Addendum No. 6, July 11th, 2025

Re: Johnson Hall Renovation – PKG 3
Johnson Hall Renovation & Foster Demolition
Tennessee Technological University
SBC Project No. 364/011-04-2022CM

3" = 1'-0"

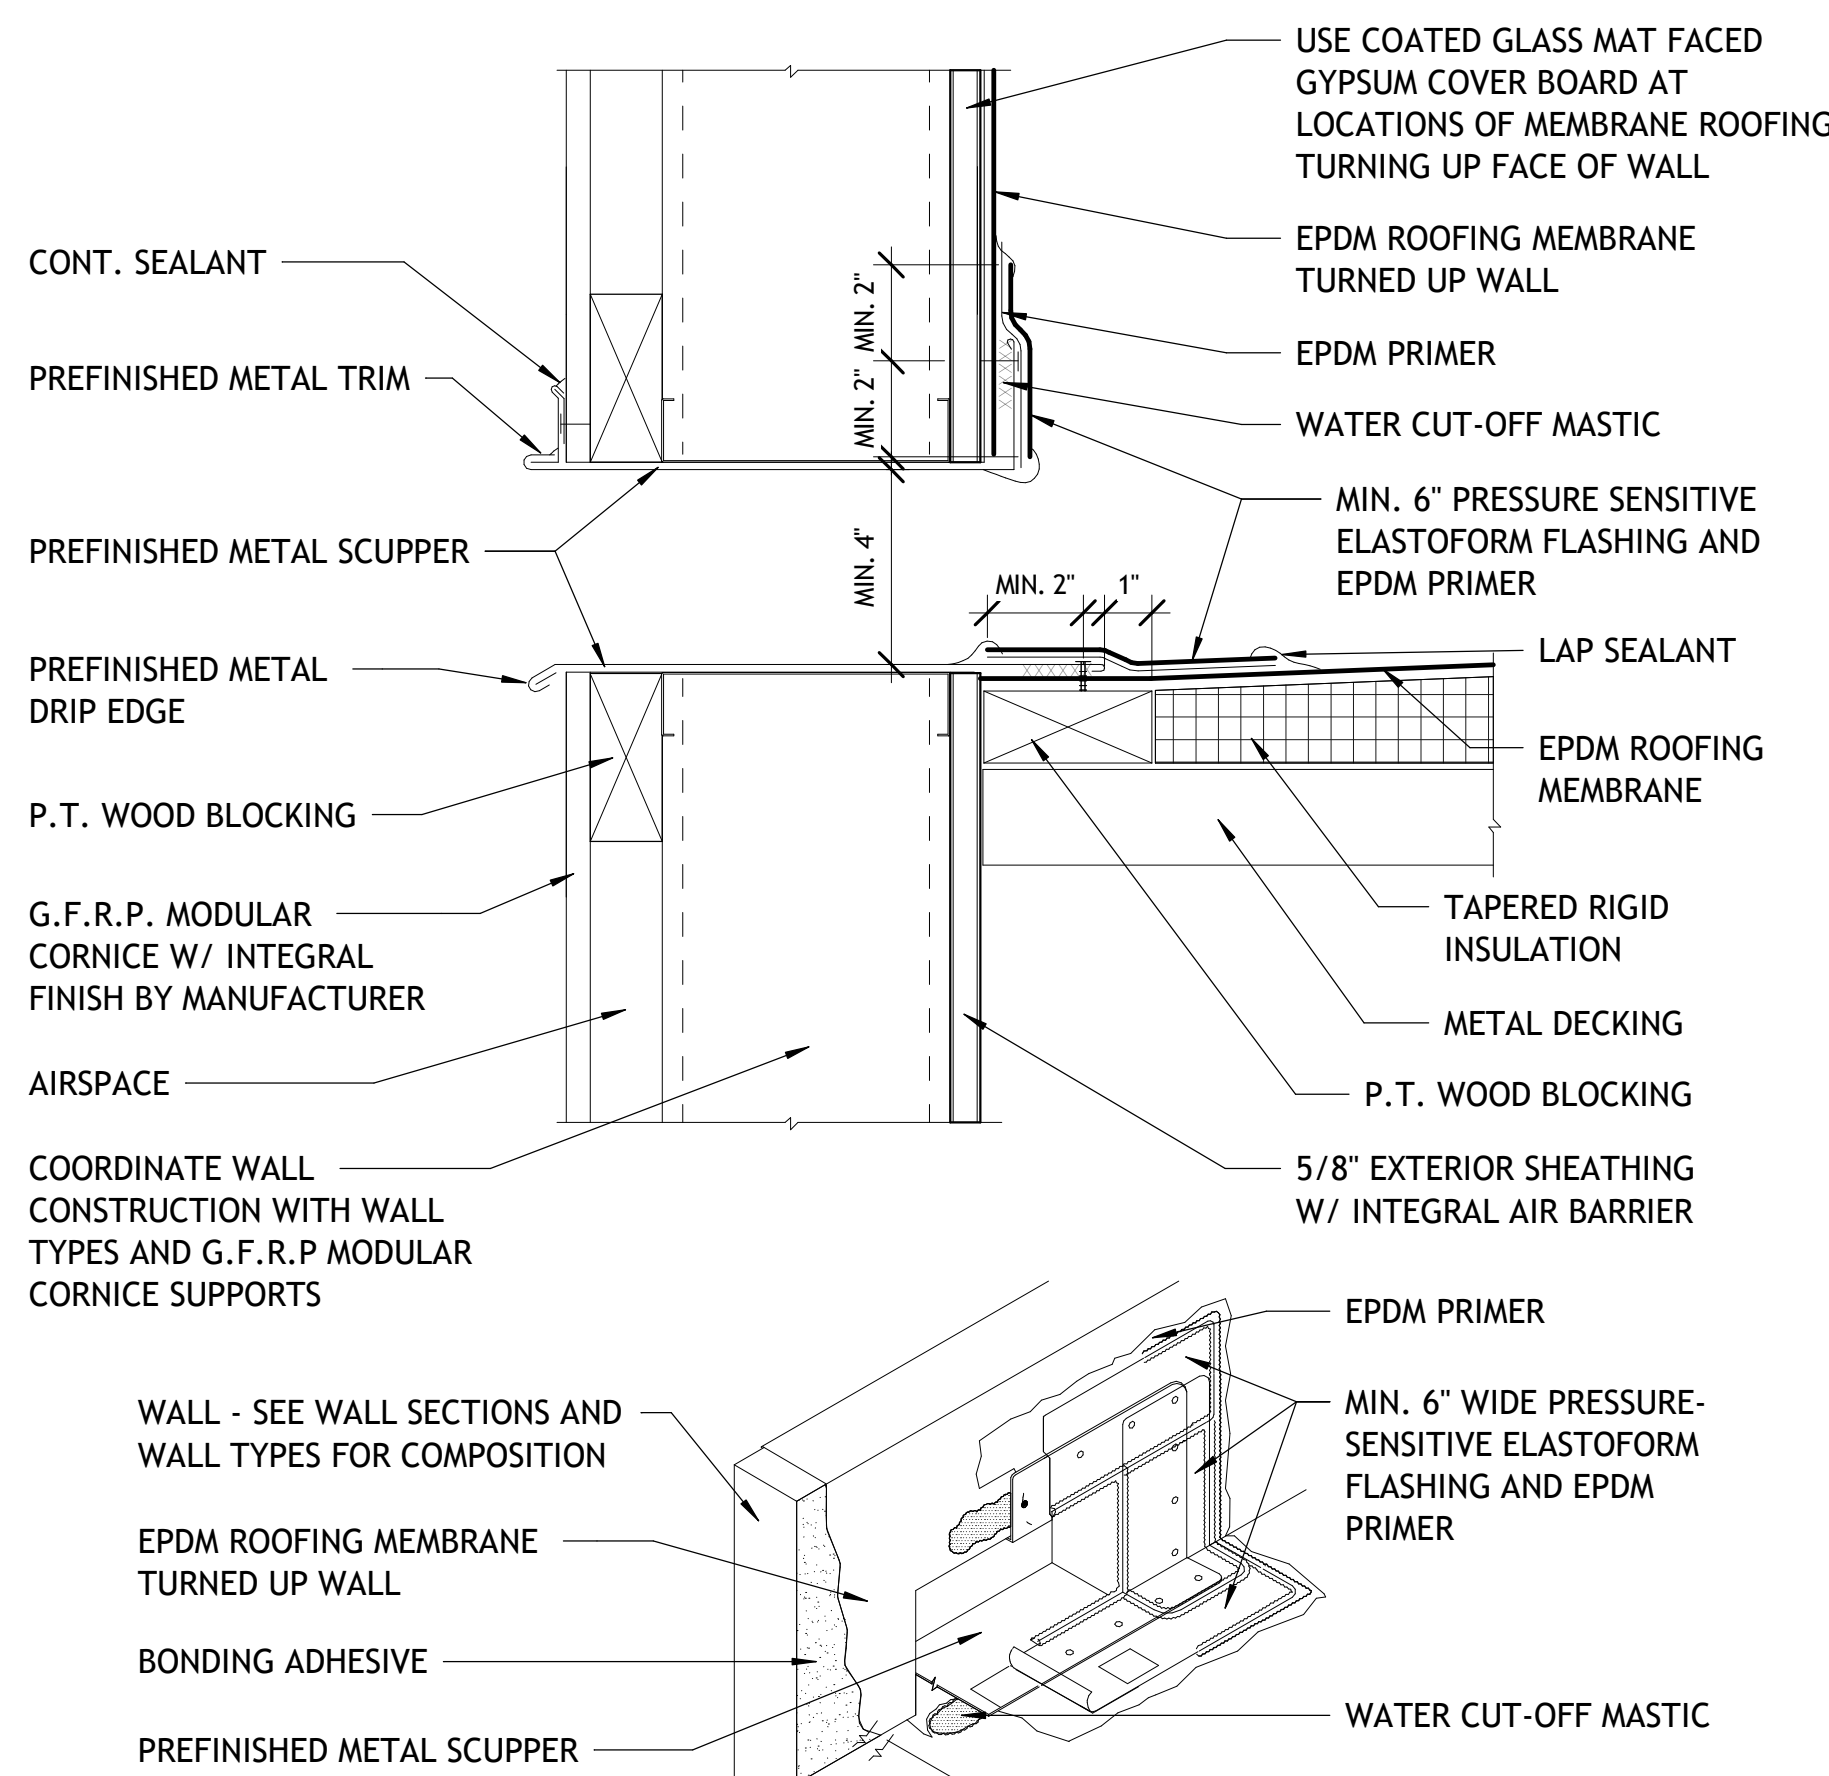
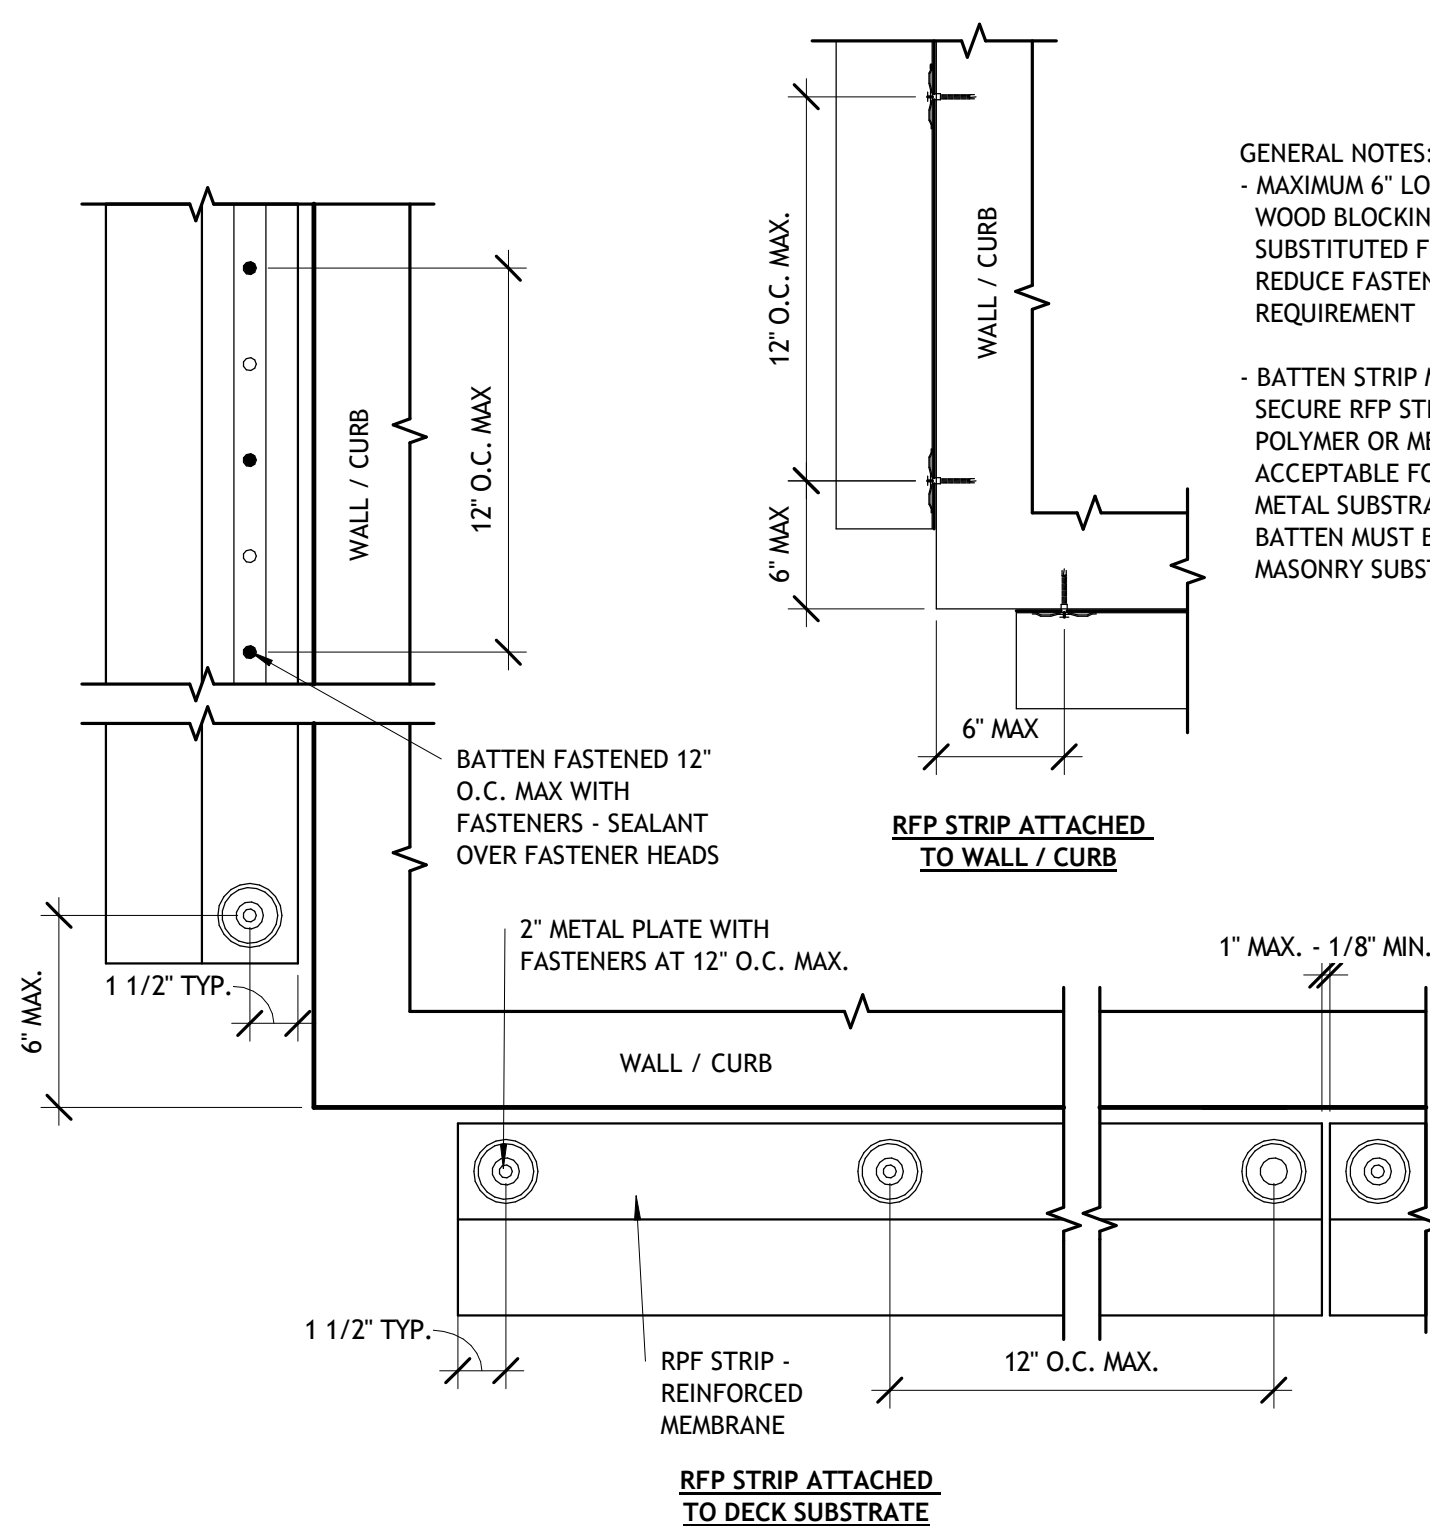
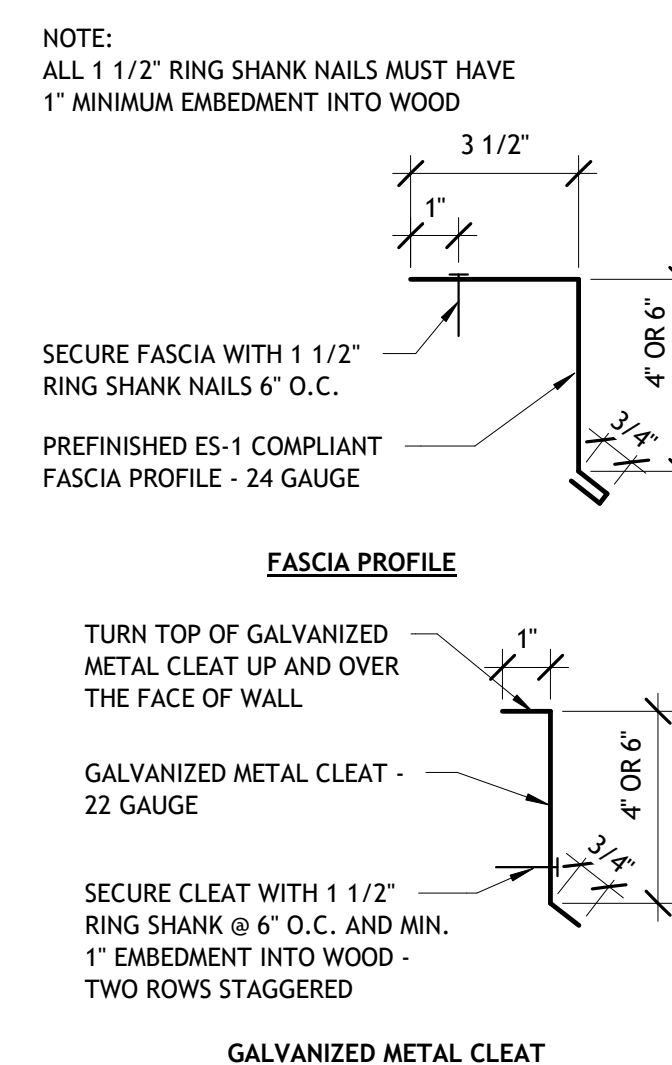
- 12) Refer to sheet A4.22 details 1 and 2. Change portico material to cement plaster on metal lath over 5/8" exterior sheathing board.
- 13) Refer to Sheets A5.12, A5.13, A5.14, and A5.15. Add prefinished metal eave vent applied to bottom of GFRP panel to locations shown on revised details.

- 14) Refer to sheets A5.12, A5.14 and A5.15. Change soffit at front portico, back portico and above exterior balcony to be a cement plaster on metal lath over 5/8" exterior sheathing board on 20 GA 3 5/8" metal stud framing @ 16' o.c.
